2 **RESOLUTION NO. 59-FY2016**

3 **RELATIVE TO APPROVAL OF THE CHANGE ORDER NO. 1 OF THE**
4 **DESIGN BUILD OF EMERGENCY STANDBY POWER GENERATION SYSTEM**
5 **FOR CASIMIRO AND NAMO SEWER PUMP STATIONS**
6 **GWA PROJECT NO. E14-001-EPA**

Subject: **E14-001-EPA**

Reference: **Change Order Proposal 01 (Rev.03)**

2 PROPOSED NEW LAY-OUT
A-1 SCALE: 1/4"=1'-0"

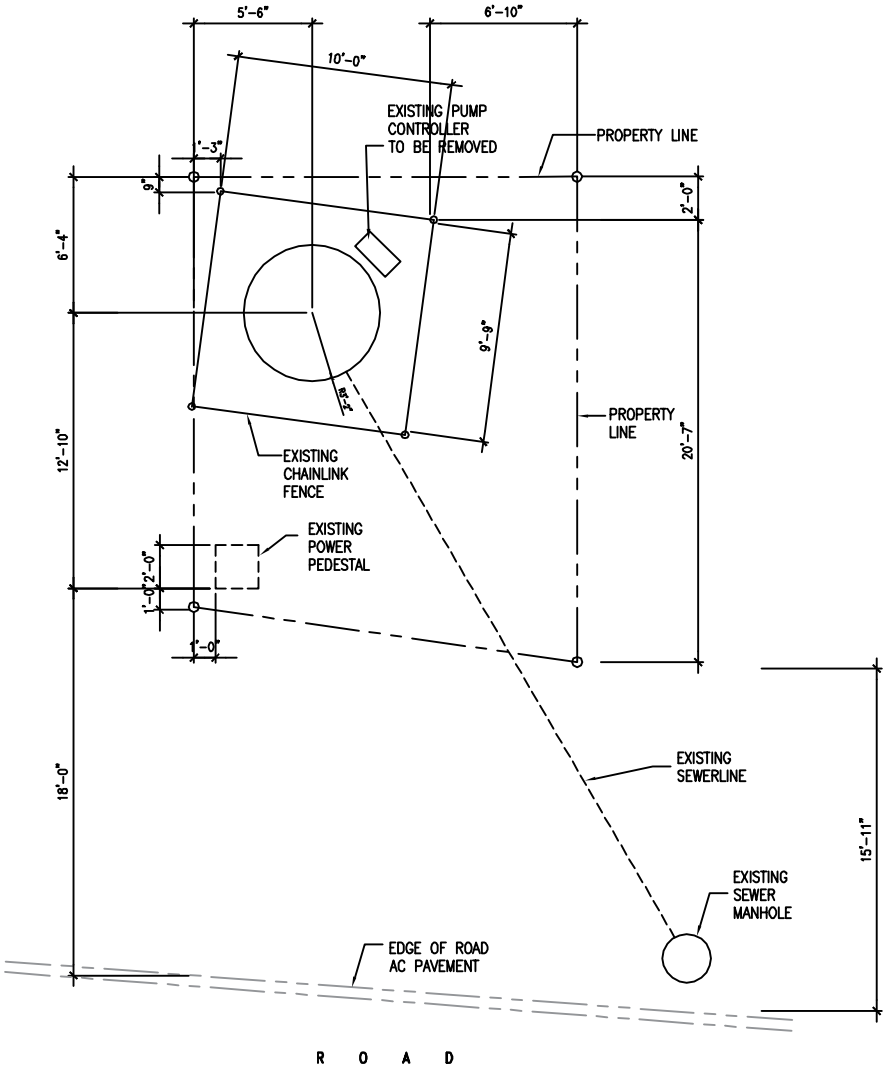
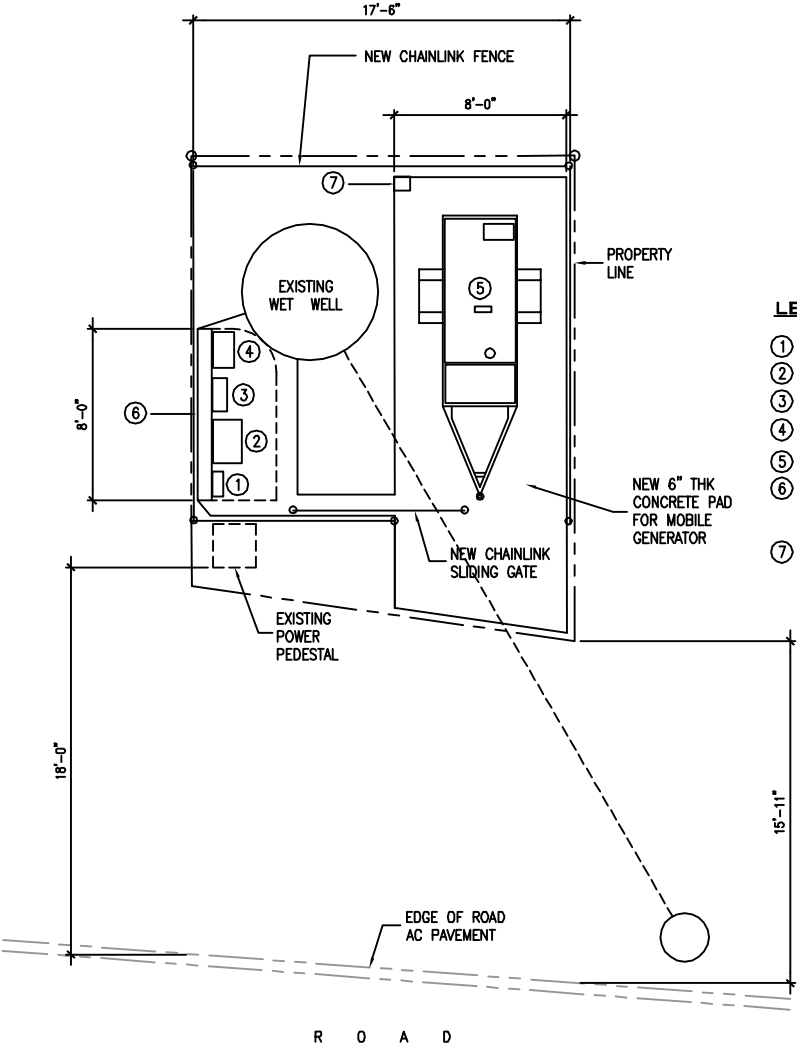
1. Delete the new building, on-site standby generator set, and fuel storage tank and replace them with a new mobile generator with trailer, a new concrete pedestal w/ cantilever concrete roof & floor slab for the new ATS, disconnect switch, pump controller, etc. The new electrical equipments shall be SSTL enclosed with special cable connectors. Mobile generator and electrical equipment will now be sized that both pumps can be running at the same time.
2. Extend chainlink fence to provide sufficient space for the new mobile generator and trailer and provide sliding gate in front of concrete pad for the new mobile generator.
3. Add a new 6" thk. concrete pad for the new mobile generator and concrete pedestal for generator power connection.

2 PROPOSED NEW FLOOR PLAN
A-3 SCALE: 1/2"=1'-0"

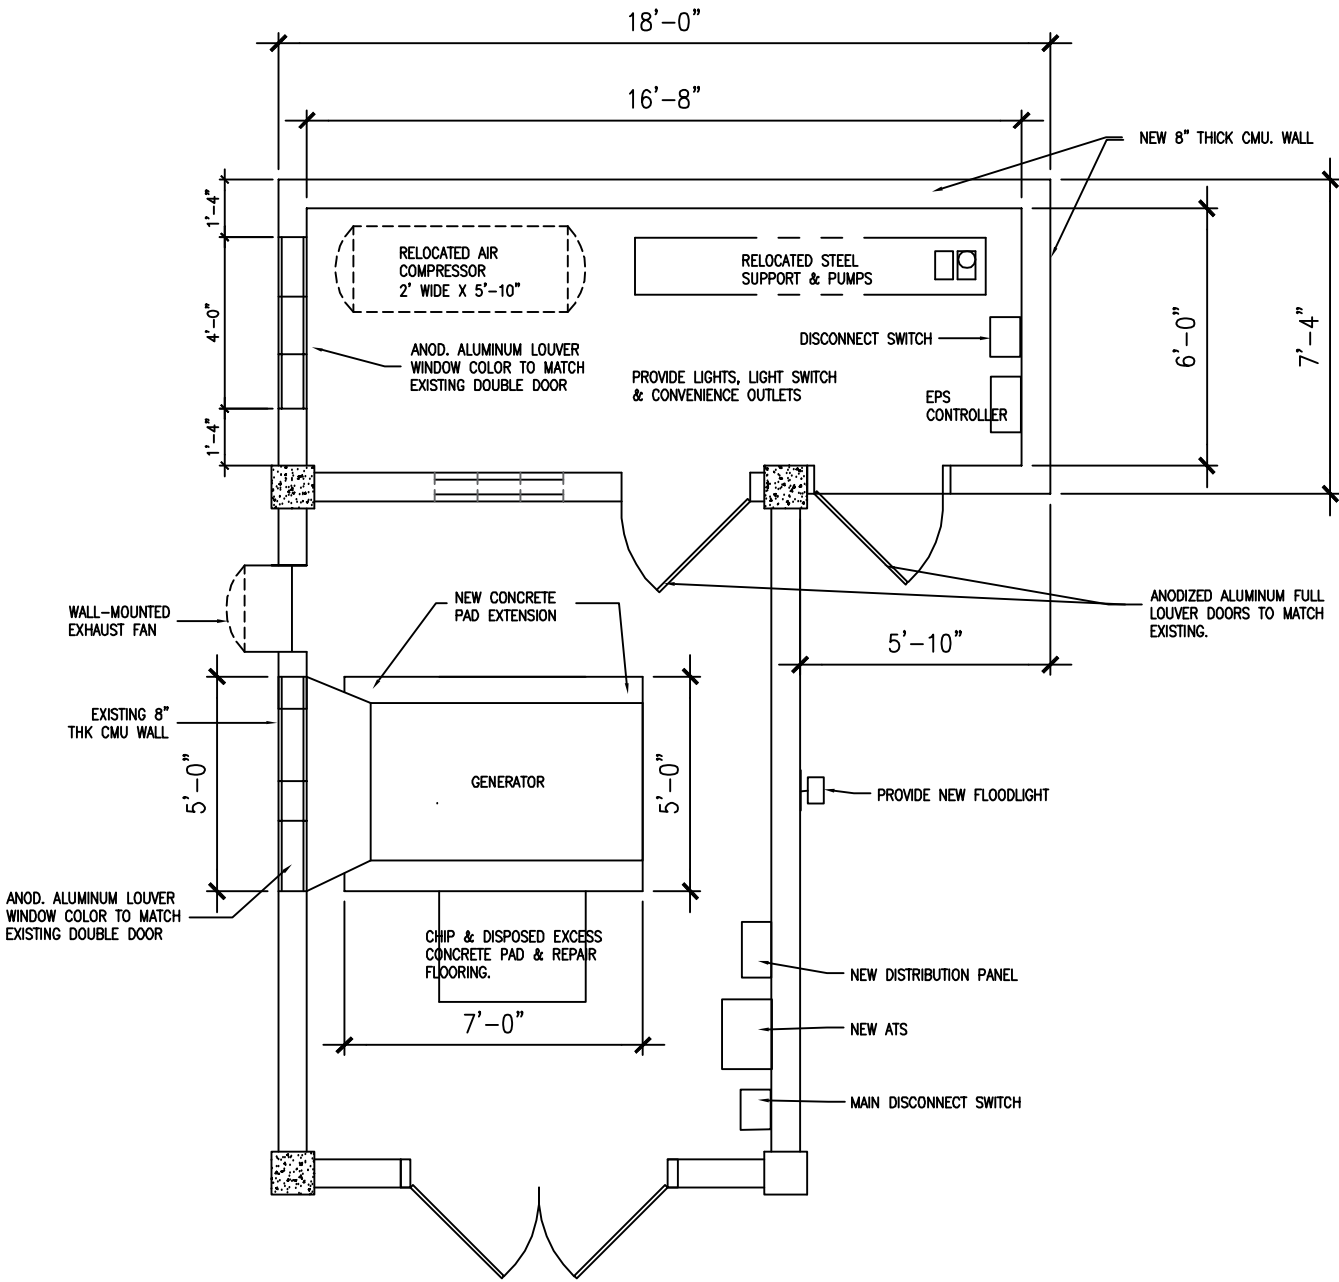
1. Add a new room in the existing generator building to shelter the existing air compressor and compressed air tank that will be relocated with 2 ea anod. aluminum louver windows with insect screen and 2 ea additional anod. aluminum door complete with door hardware.
2. Provide mechanical wall-mounted ventilator on existing building complete with controller.
3. Emergency stand by generator, fuel storage tank, electrical equipments to be sized that both pumps can be running at the same time.

2 PROPOSED NEW LAY-OUT
SCALE: 1/4"=1'-0"

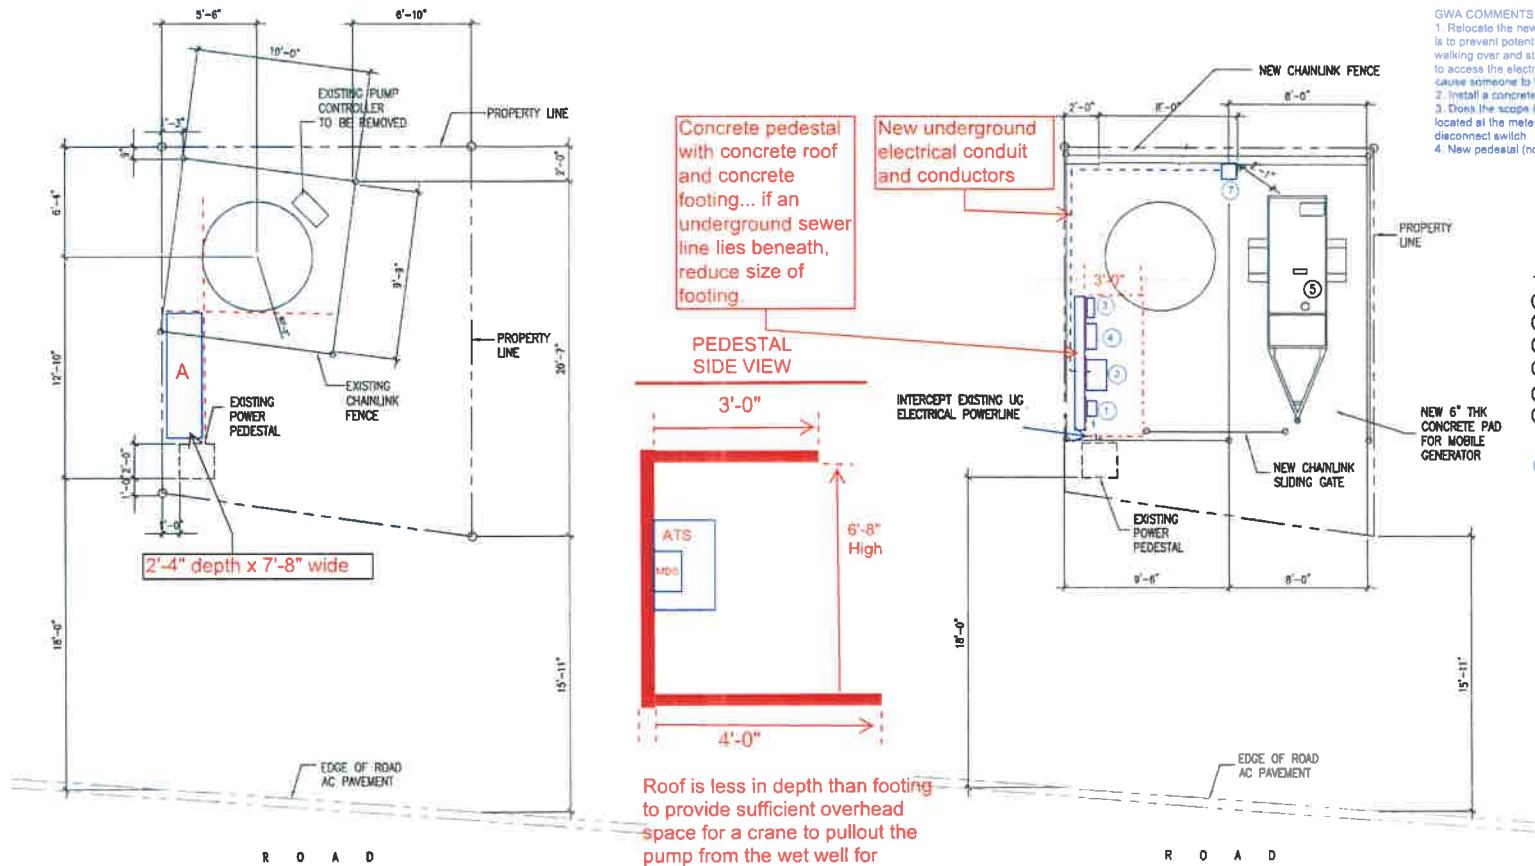
1. Relocate the new concrete pedestal and panels. The relocation is to prevent potential hazard of having GWA and GPA personnel walking over and standing on the concrete pad of wet well in order to access the electrical panels. The handle of the cover can also cause someone to trip.
2. Install a concrete footing and roof for new concrete pedestal.
3. Does the scope include removing the existing disconnect switch located at the meter pedestal? It is being replaced by the new disconnect switch.
4. New pedestal (no. 7) has been added for generator connection.

Roof is less in depth than footing to provide sufficient overhead space for a crane to pullout the pump from the wet well for replacement.

The existing concrete pad on the wet well is removable. It shall remain removable after construction of new roof and footing.

2 PROPOSED NEW LAY-OUT
SCALE: 1/4"=1'-0"

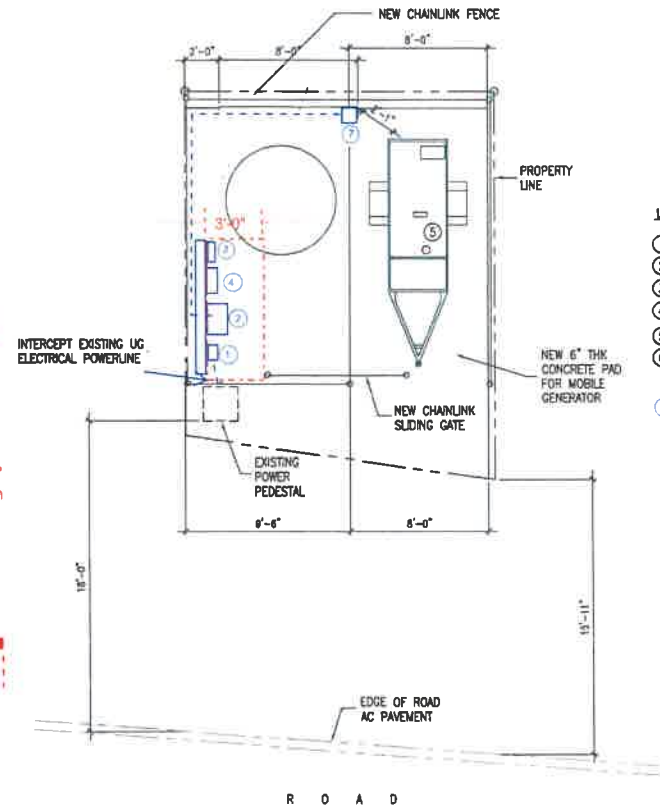
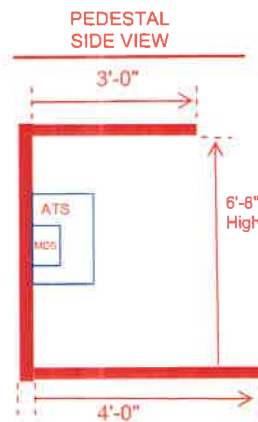
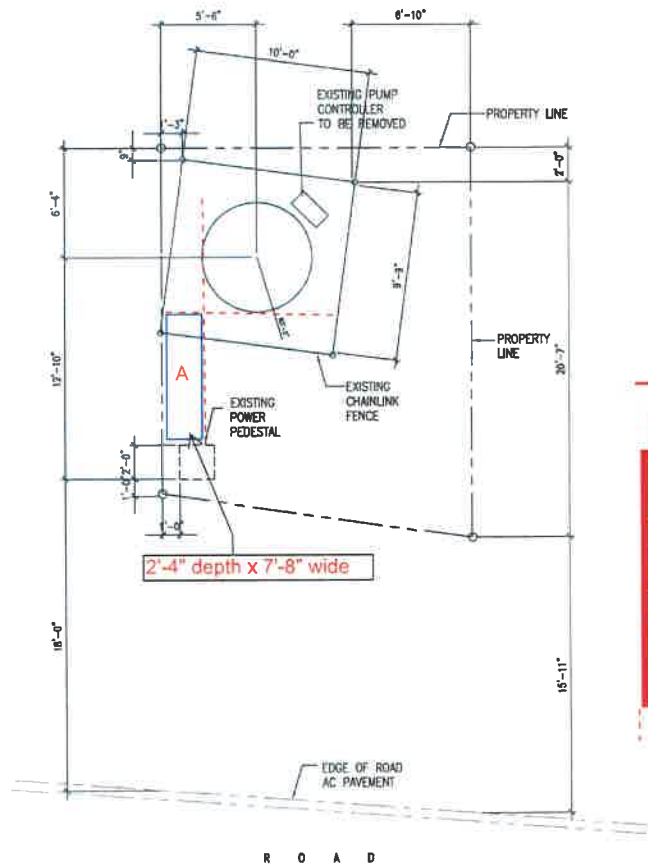
2. Add concrete overhang (roof) and footing as shown. This can provide some protection to personnel and panels from rain and sun heat. Footing should be deep enough to have a person stand on concrete while standing in front of ATS or other panels. Confirm footing is not constructed on top of an existing underground sewer line. Design the overhang or roof to not obstruct pump pullout using a crane.

3. Concrete pad must be constructed to sustain a weight load of a heavy vehicle such as a crane.
4. Add an additional pedestal (marked as no. 7) for provision to connect the generator.

5. Scope includes removal of the existing disconnect switch located at the meter pedestal. It will be replaced by the new disconnect switch.

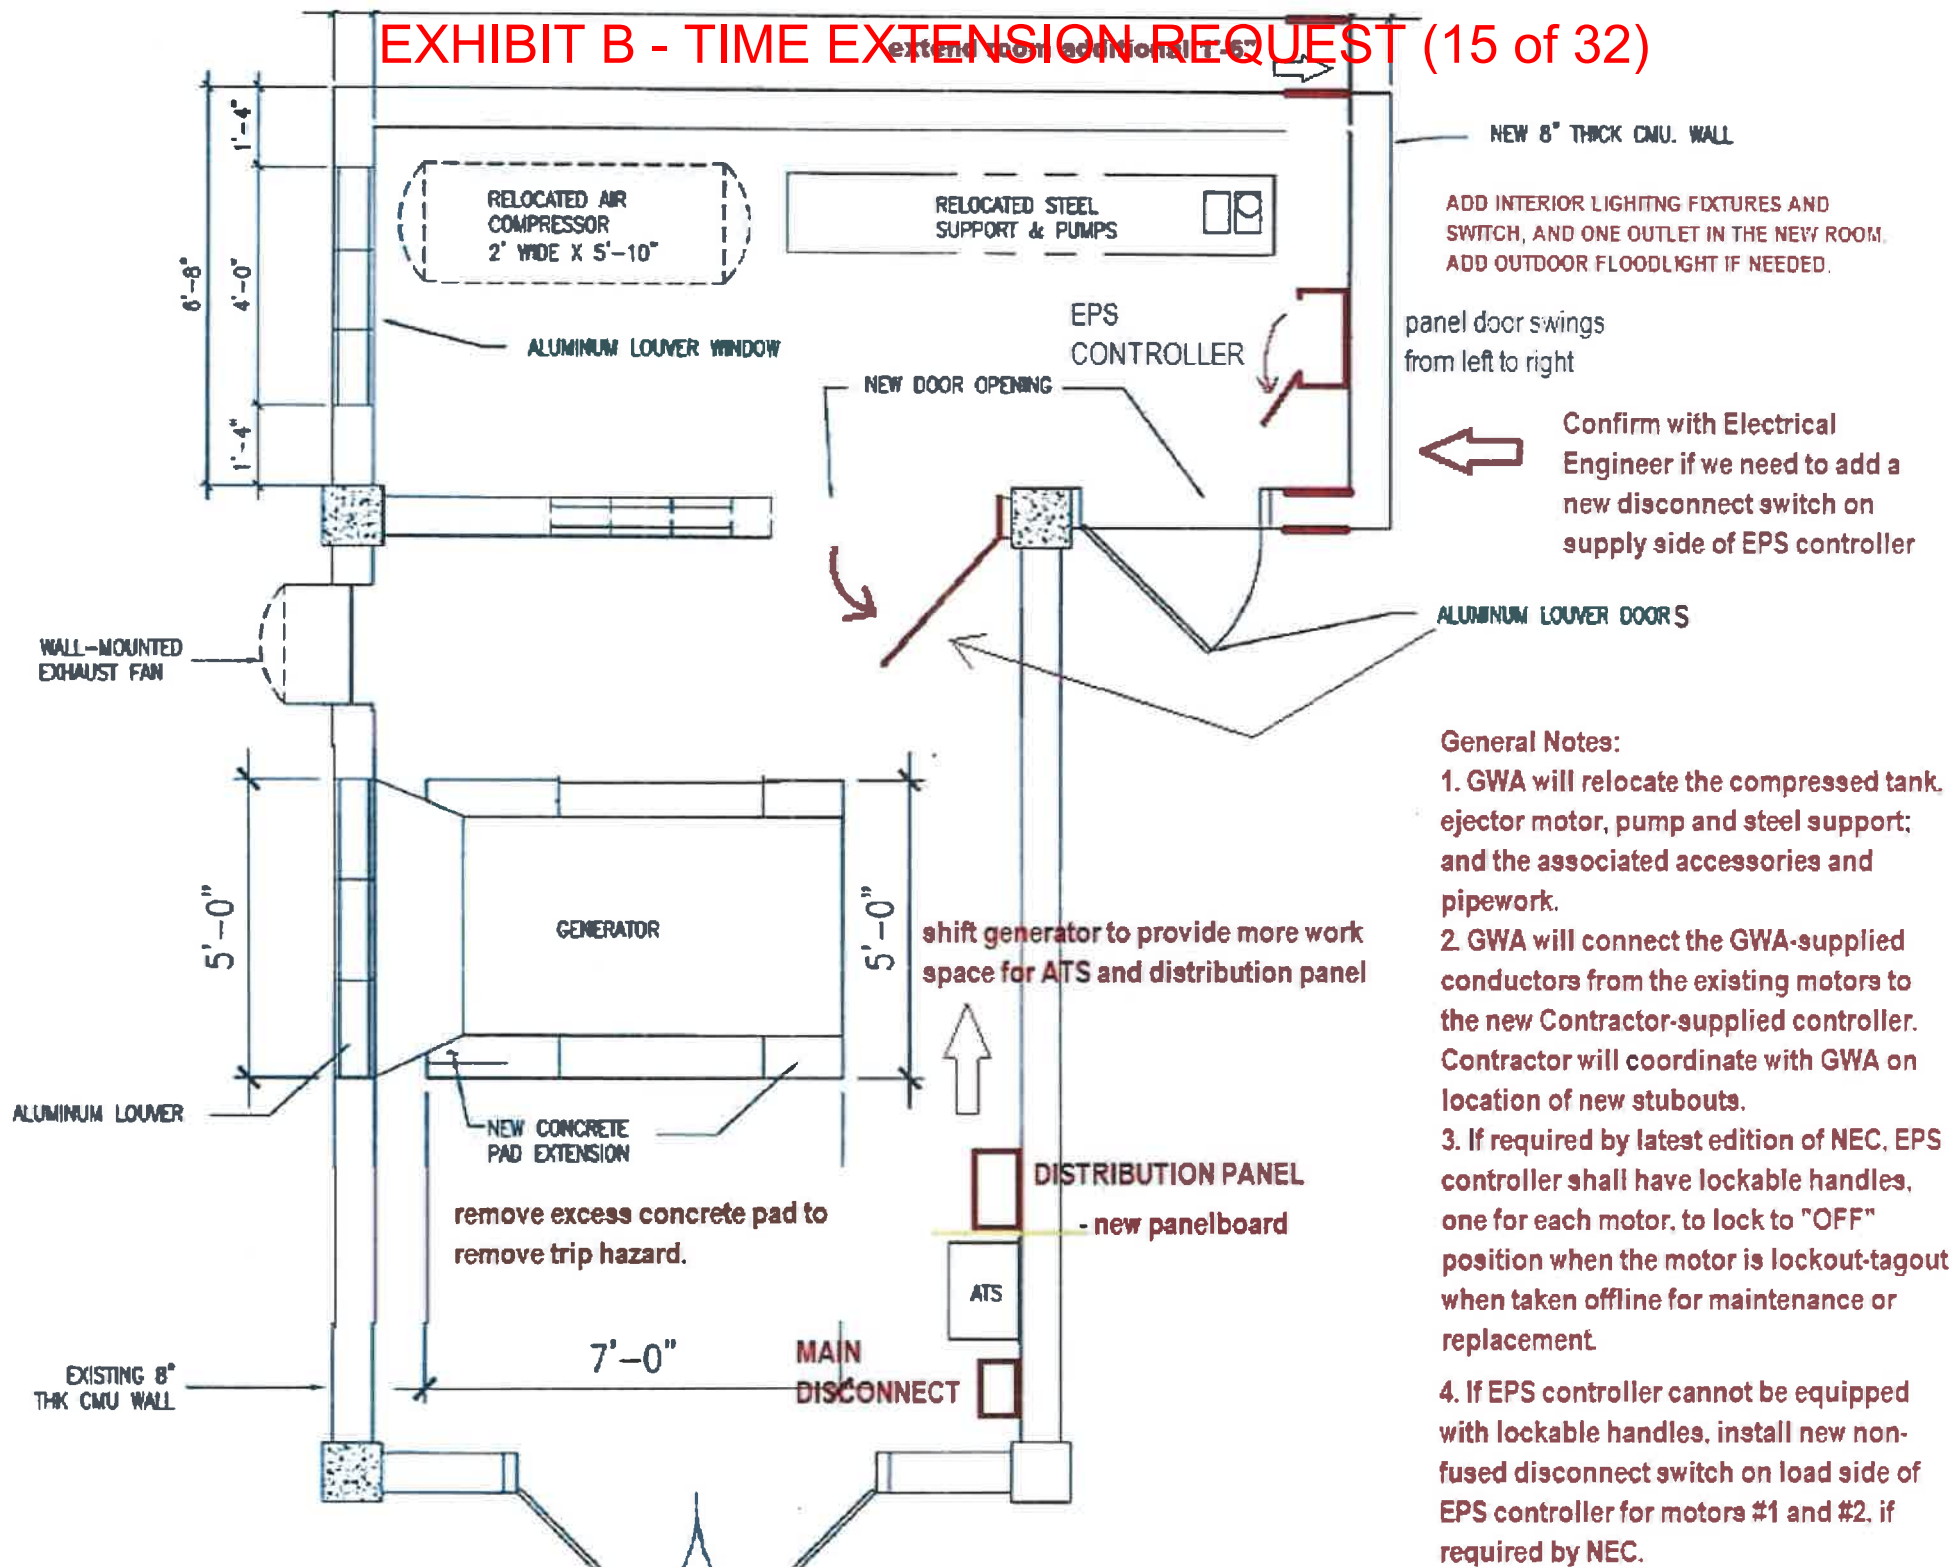
1. Locate the EPS controller in new building extension in order to have the controller and motors in the same location to see the response of motor and pump when operating them from the controller.

3. Extend the new building extension an additional 1'-6" as shown to provide additional work space for the EPS controller when there is foot traffic entering/exiting the room through the new single door.

4. To be confirmed by the electrical design engineer, add a new non-fused disconnect switch on supply side of the EPS controller if required by NEC.
5. Add interior lighting, light switch and one electrical outlet in the new building extension.

6. Add new exterior floodlights if needed.
7. Add one single aluminum louvered door at the new door opening between the new building extension and existing generator building to reduce the noise when the generator is running. The door shall swing from left to right as shown. This will provide some wall space (the wall with the décor blocks) for future panels.

8. Slide the generator set and wall mounted ventilator as shown to provide wall space and work space for the new main disconnect switch, ATS and panelboard.

10. Remove excess concrete pad of generator to remove tripping hazard.
